APPLICATION NO:
F/2000/2774

LOCATION:
3, Ardwell House Ardwell Close, Crowthorne.

PROPOSAL:
Proposed 3 storey side extension to dwelling.

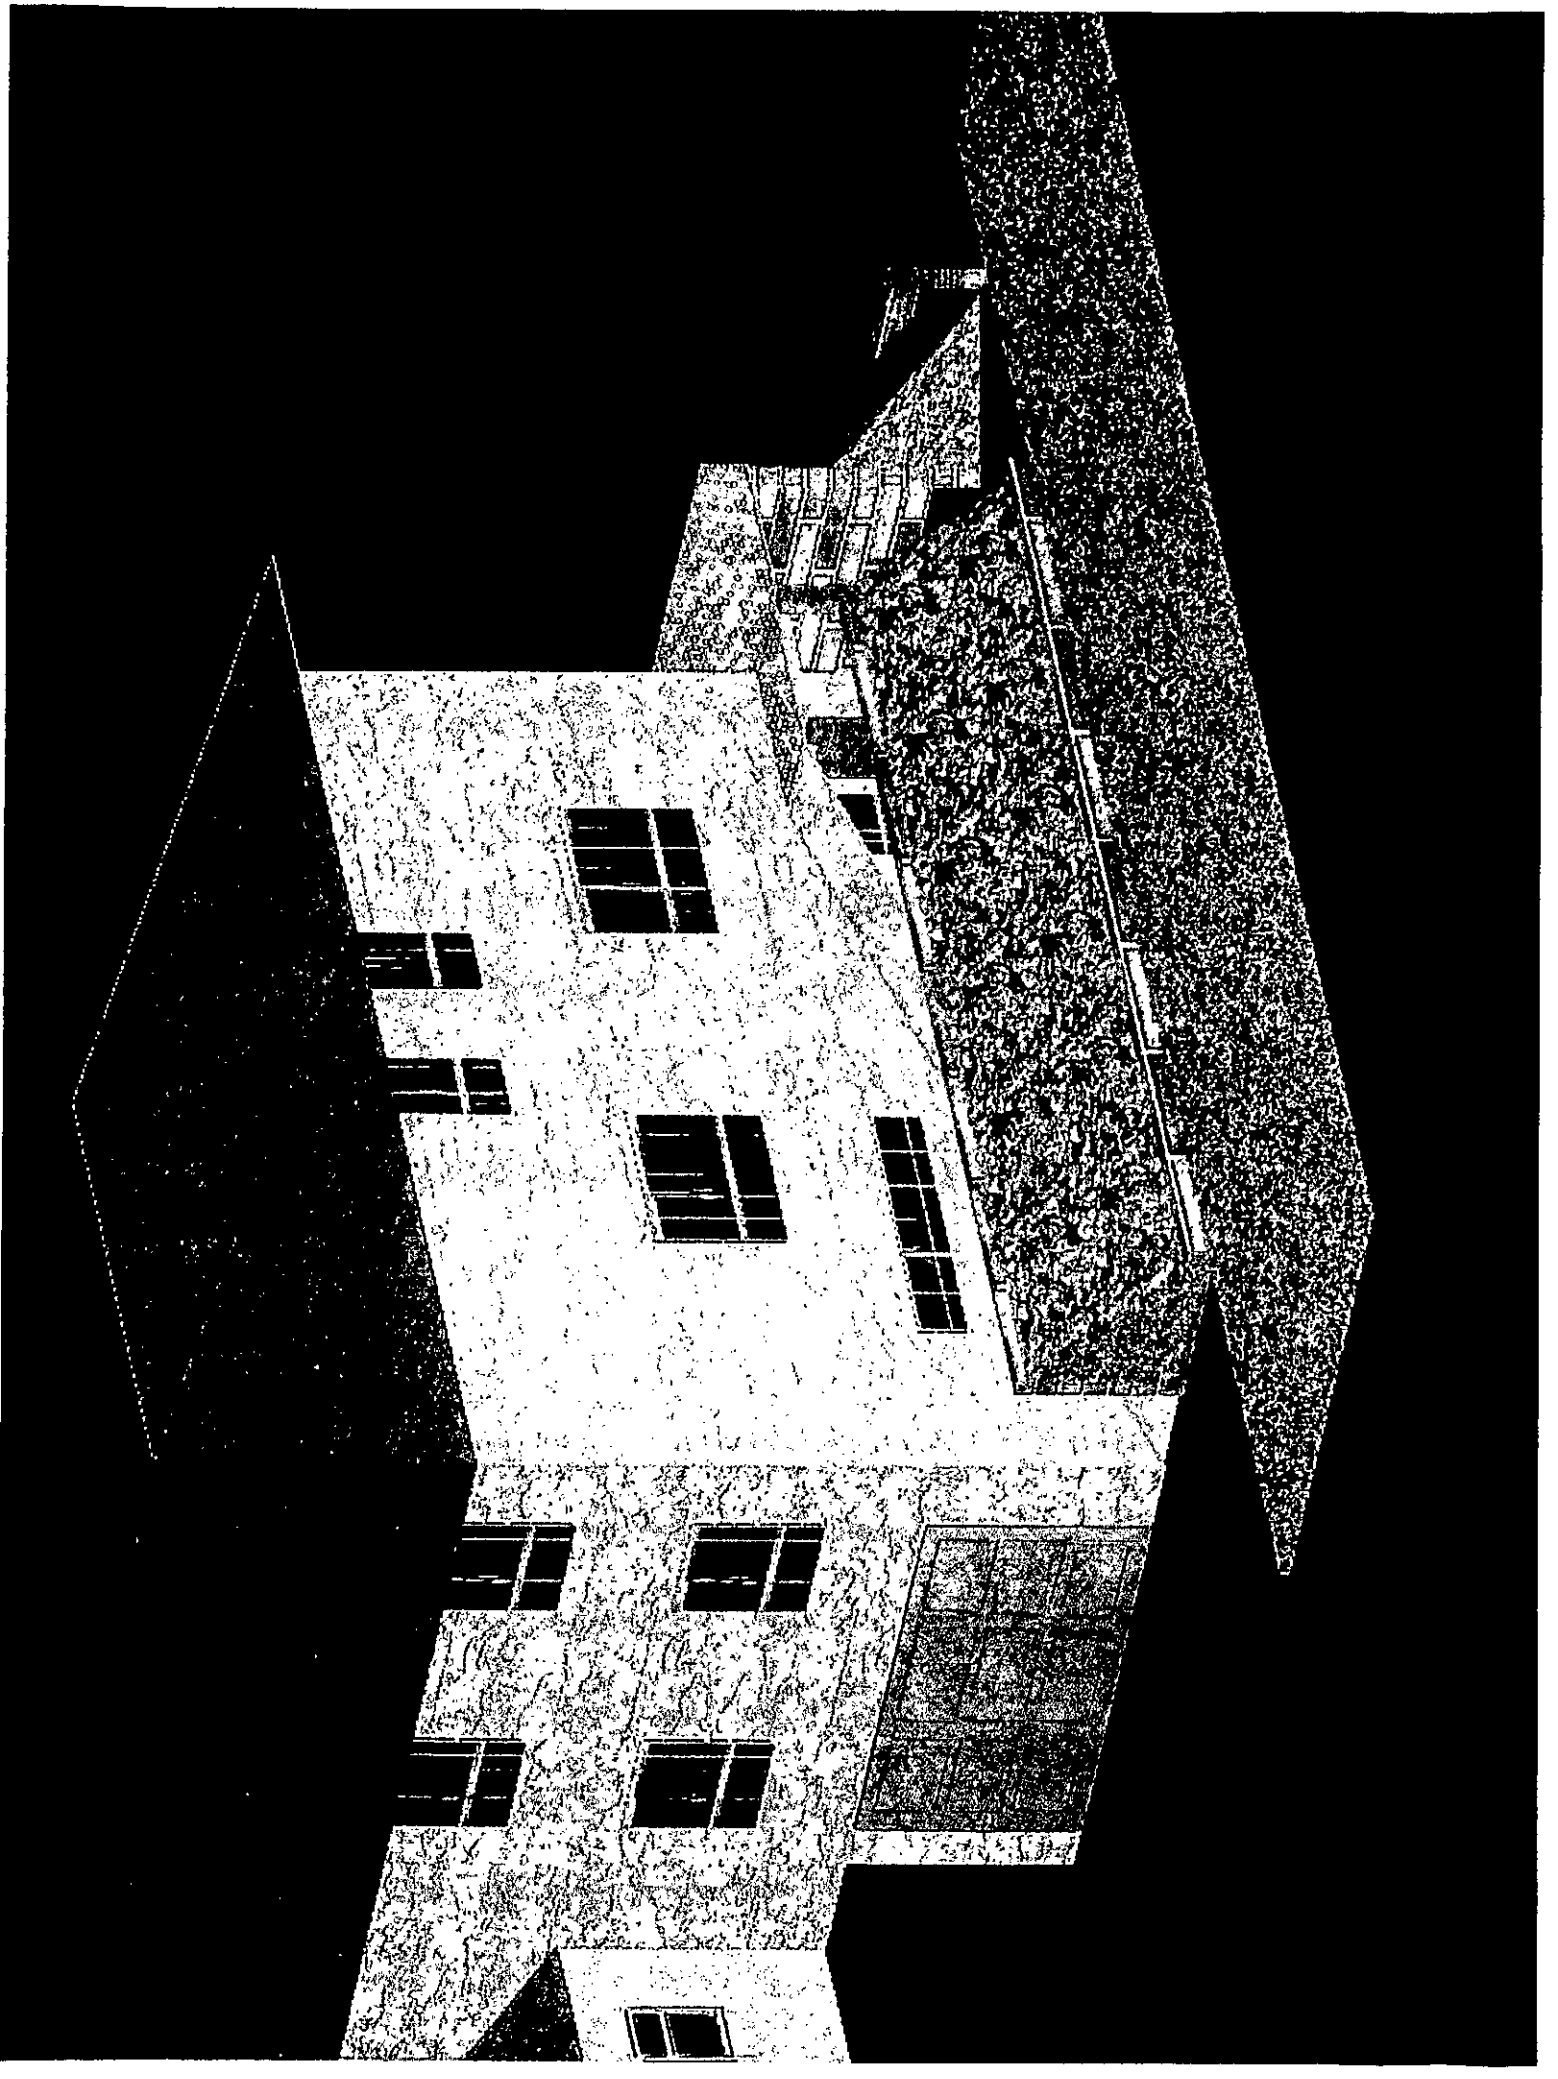
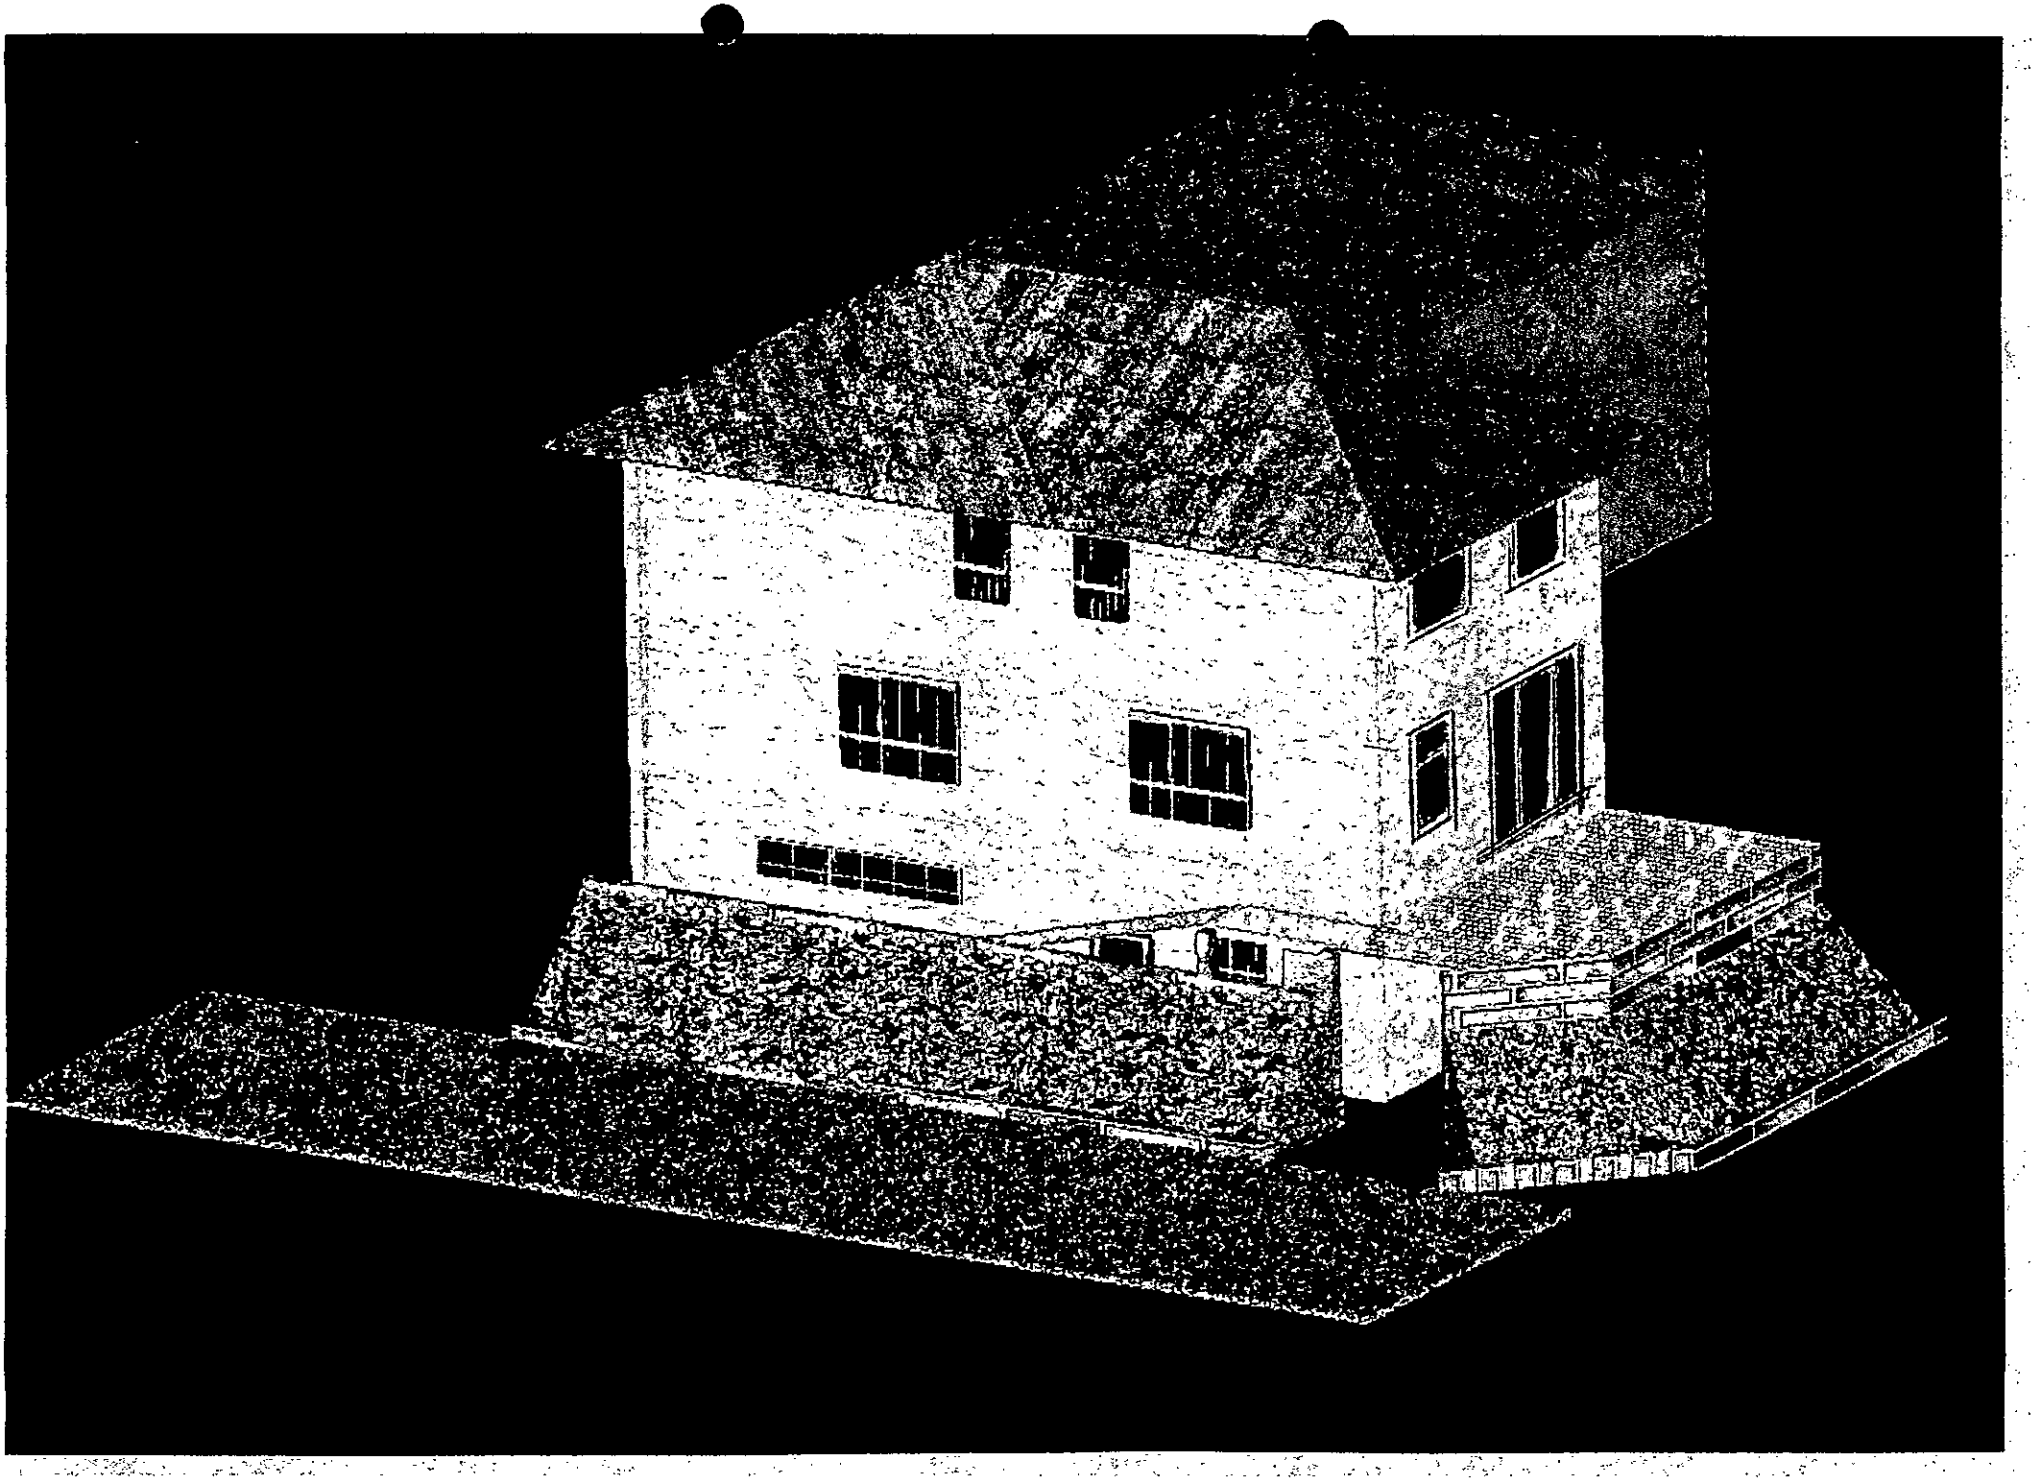
Further to my recent telephone calls to your office, please find enclosed two artist's impressions of the proposed re-location of the soil, using a retaining wall and decking for a walkway to the side of the house.

If this system is within keeping with local regulations so that we can achieve the three storeys, can you please let me know as soon as possible so that I can ask my agent to amend the plans for resubmission to you.

Unfortunately, the illustrative scheme is not considered to be a significant improvement on the above scheme. Instead, it rather illustrates the impracticality of providing a 3-storey extension that would not be overbearing when seen from neighbouring properties.

If you would be satisfied with a 2-storey scheme, please supply revised drawings omitting the top floor and reducing the roof height by one storey. If your requirement is for 3-storeys, you may wish for the application to be determined as it stands. Assuming the application is then refused, you would subsequently have a right of appeal to the Planning Inspectorate. If I do not here from you within 10 days, I shall assume that you wish for the application to be determined as originally submitted.

I apologise for any confusion that may have arisen over what is likely to be acceptable. I had requested from your agent, Mr Sparrow, a contour plan of the surrounding land, so that the practicality of his suggested banking at the side of the extension could be assessed. He not unreasonably did not wish to incur the cost on your behalf, without some indication that such an option may be acceptable. It is only now evident from your perspectives that the land drop to the side of your existing property makes such an option unacceptable.

SCALE: 1:50 DRAWN. G.W. SPARROW, DWG. NO. GWS/1777/00/3.

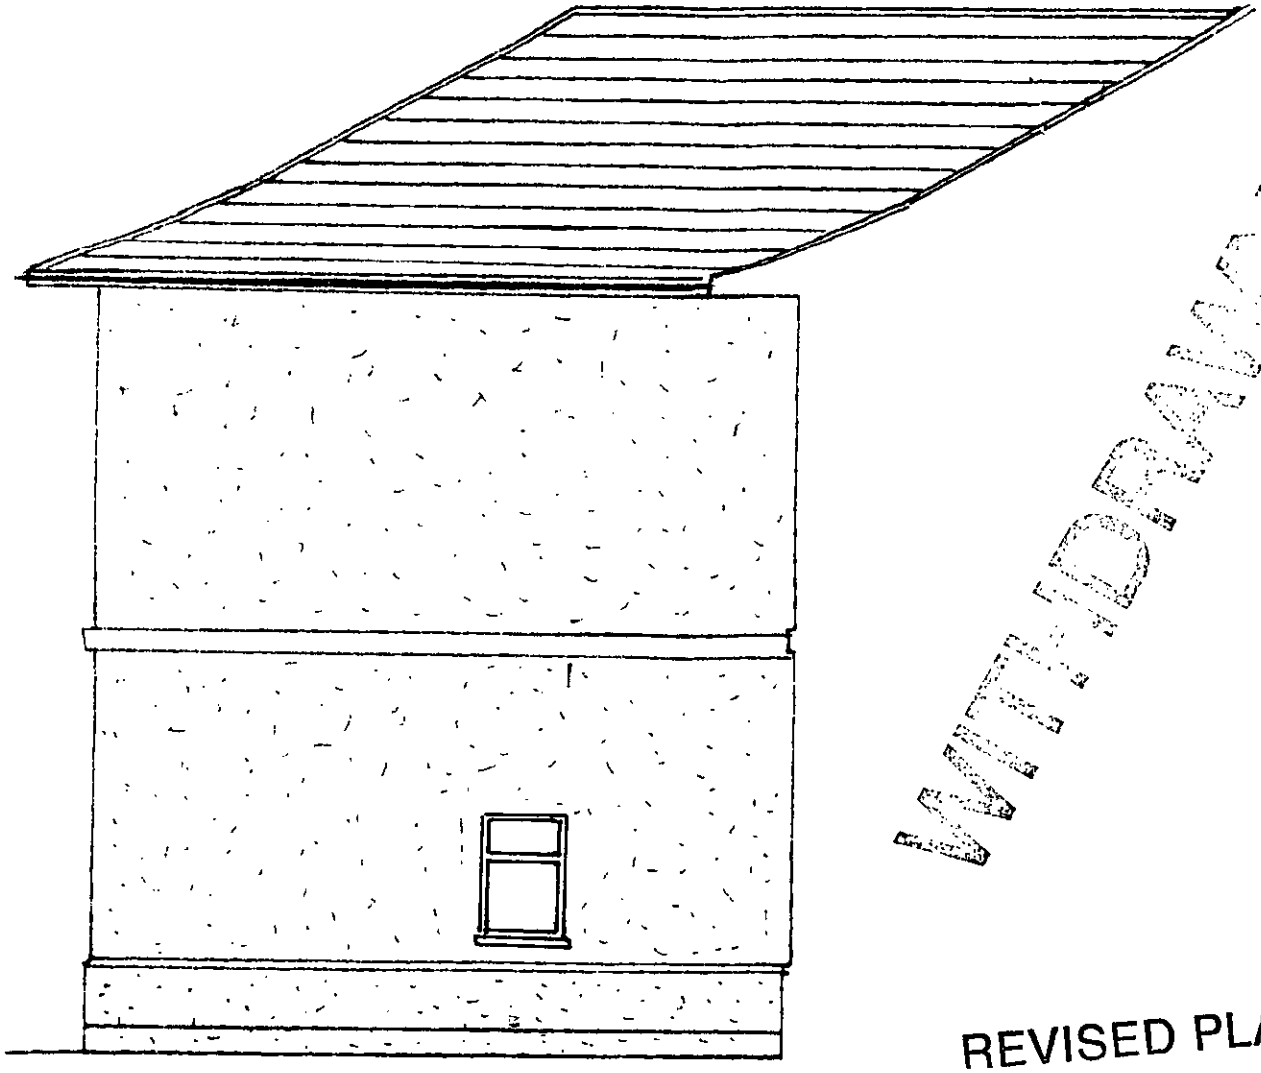
The new plans show the following: Side elevation corrected to show stairs window in ground floor. Drawing no GNS/1777/00/3.

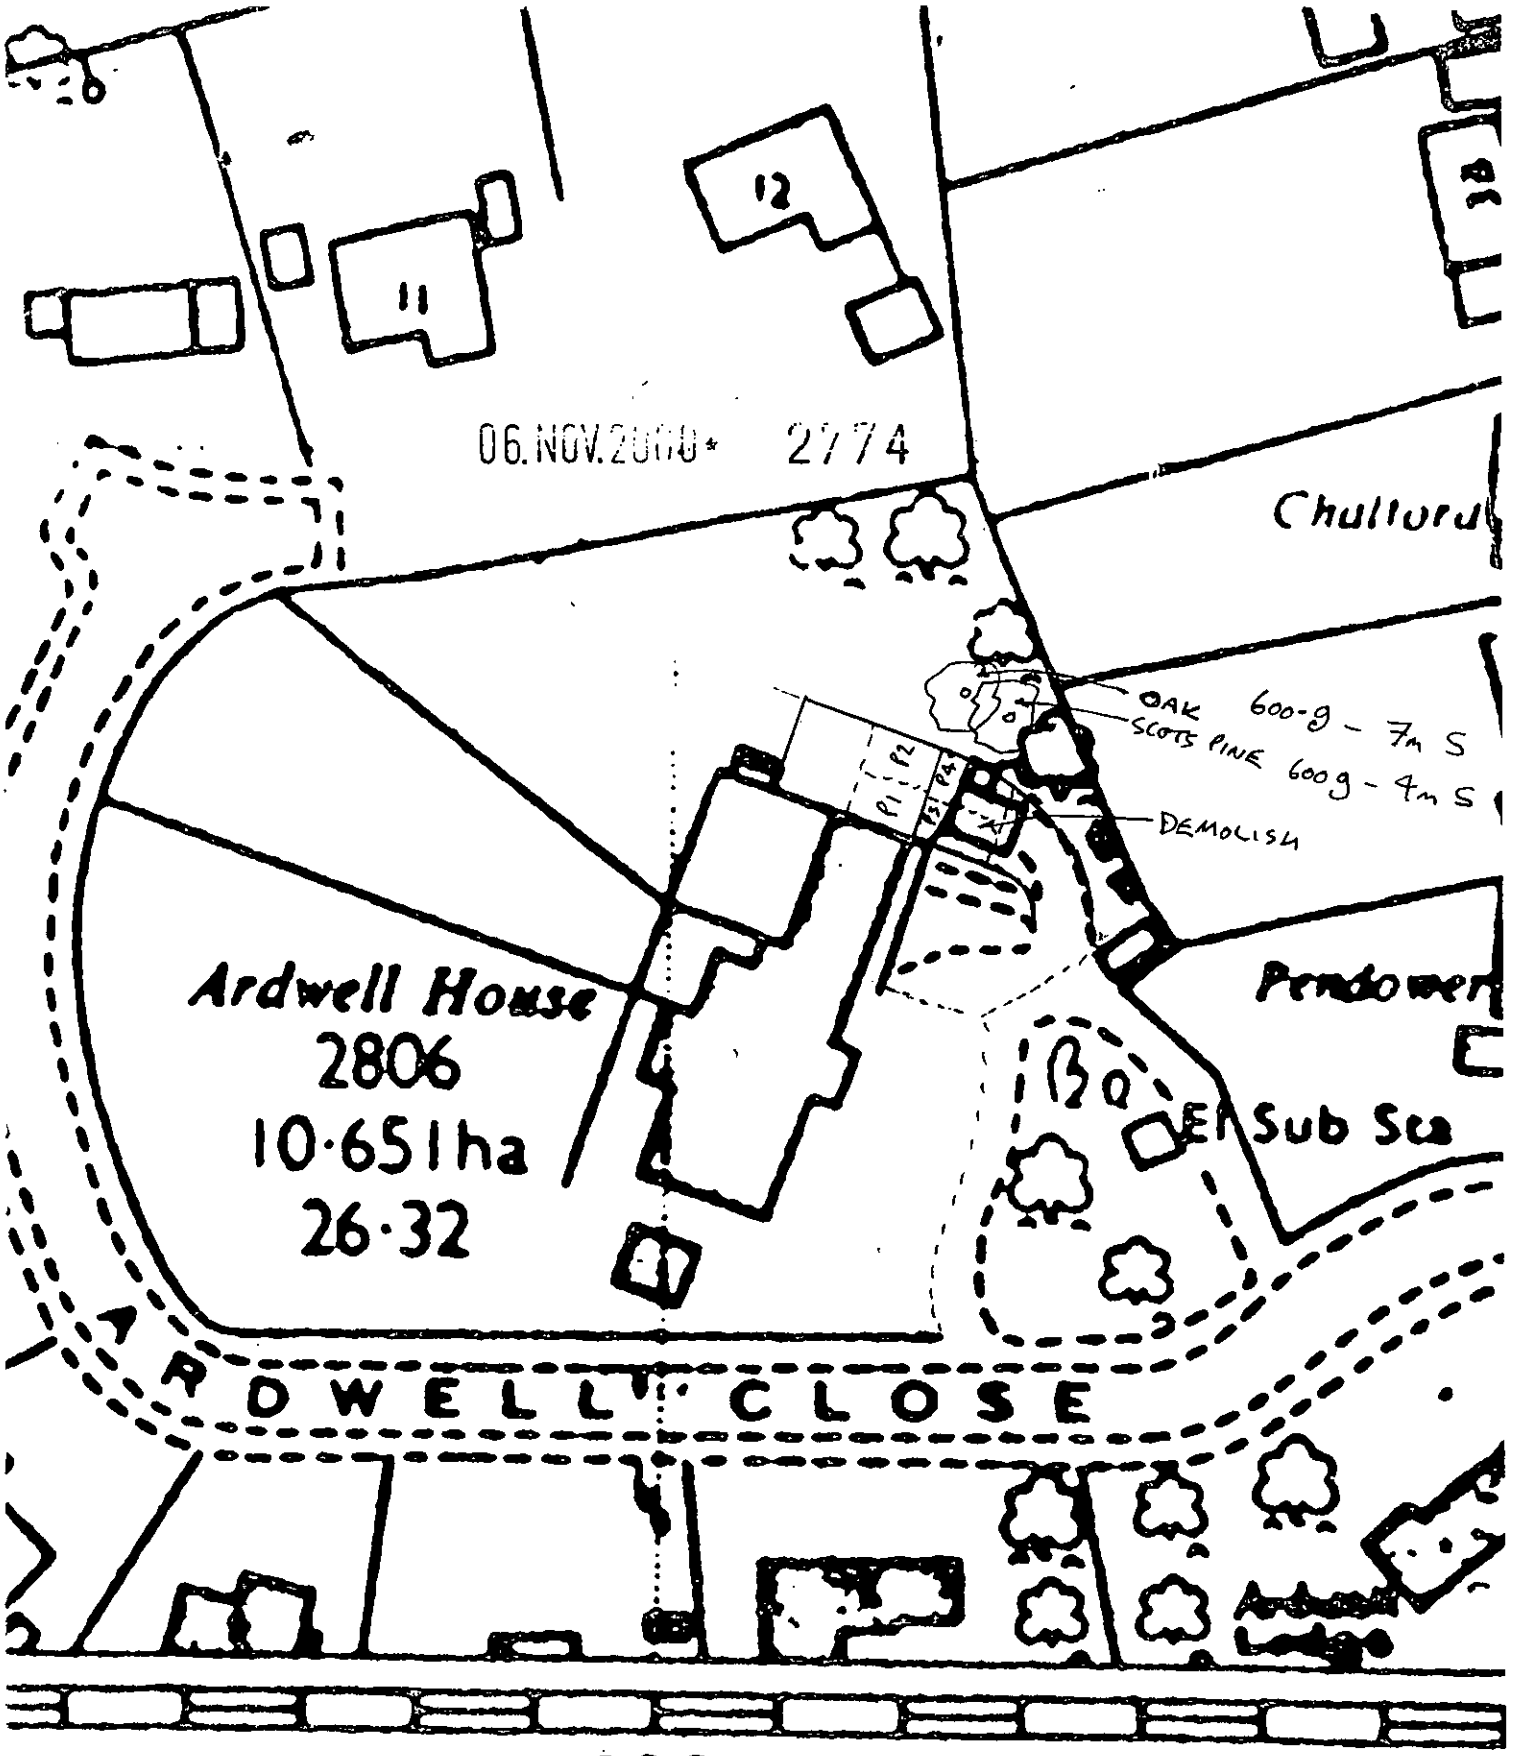
I am surprised to find that the location map is totally out-of-date showing the original development in Ravenswood Avenue as it was some 40 years ago.

The site map is completely erroneous. Pendower is no. 27 Ravenswood Avenue and Chalford is No. 31. We at No. 29, who will be the most affected by the proposed building, are not shown at all. Surely the application must be made showing the site as it is today.

We are concerned that the plans do not show the trees on the site. There are many splendid specimens and the application should show any that it is proposed to fell. Some years ago an application to demolish Ardwell House and develop the site was rejected and in rejecting an appeal the inspector noted the implied loss of prime trees.
